Lot 2 Officer South Road, Officer South – Drainage Review

26th October 2023

30158708

Human Habitats on behalf of the Lumanovski family

Figure 1: Lot 2, Officer South and the proposed wetland and retarding basin.

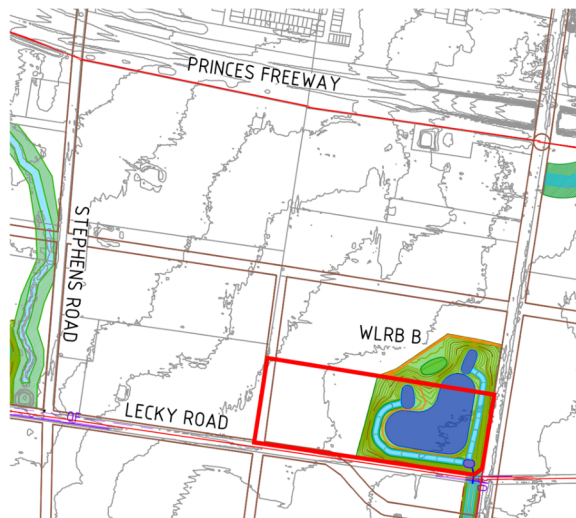
The drainage scheme proposes a wetland with reserve area of 9.1ha to treat a combined catchment of 94.63ha.

- The impervious percentage of the combined 94.63ha catchment is set to 90%. This figure does align with the typical value for industrial land stated in MW's MUSIC guidelines. However, 90% is conservative and MW's guidelines provide a range of 70-95% which may be adopted for industrial land. A reduction in the assumed impervious percentage of the catchment impacts the volumes and timing of runoff entering the wetland. There is an opportunity to optimise the modelling to decrease the size of the wetland.
- The initial storage of pervious areas is set to 25%. MW's guidelines do not include a typical value, however the MUSIC User Manual, which the MW's guidelines reference, includes a typical value of

36%. Adjusting the initial storage to 36% reduces initial runoff from pervious areas, with the significance of the impact increasing as the combined catchments impervious percentage is decreased.

Figure 2: MUSIC model catchment plan excerpt.

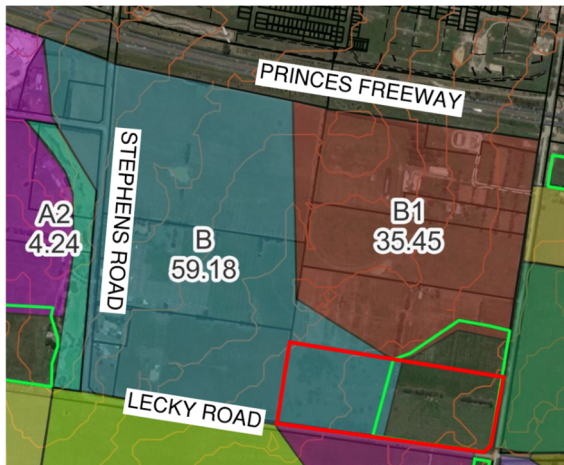
The combined catchment that the wetland is to treat is shown in Figure 2 as B and B1. The southeast corner of the site contains the low point of this catchment; however, it is not equitable to burden the site with the loss of developable land to an extent not shared by any other lot in the catchment. Maintaining the current proposed reserve area of 9.1ha, the configuration of the wetland could be modified to share the loss of land equitably with the lot north of the site, as shown indicatively in Figure 3. Should the reserve area of 9.1ha be reduced, additional developable land would be available on both lots.

Figure 4: Mark up of realigned Lecky Road and remnant land to the south of the site.

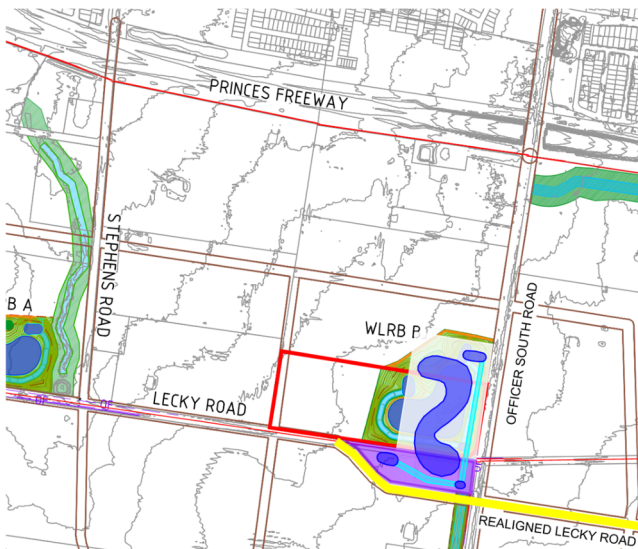
Lecky Road will be realigned and shifted south as it approaches Officer South Road from the west as marked up in yellow in Figure 4, creating a parcel of land to the south of the site that is highlighted purple in Figure 4. This parcel of land, between the wetland, Officer South Road, and realigned Lecky Road could be incorporated into the reserve area. This would share the loss of land associated with the wetland with an additional landowner and improve the accessibility of the reserve area by introducing access along Lecky Road. The realignment of Lecky Road was not proposed when the Officer South DSS Options Assessment (Jacobs, 2022) was completed. It is noted that there is an existing gas utility running north-south along Officer South Road.
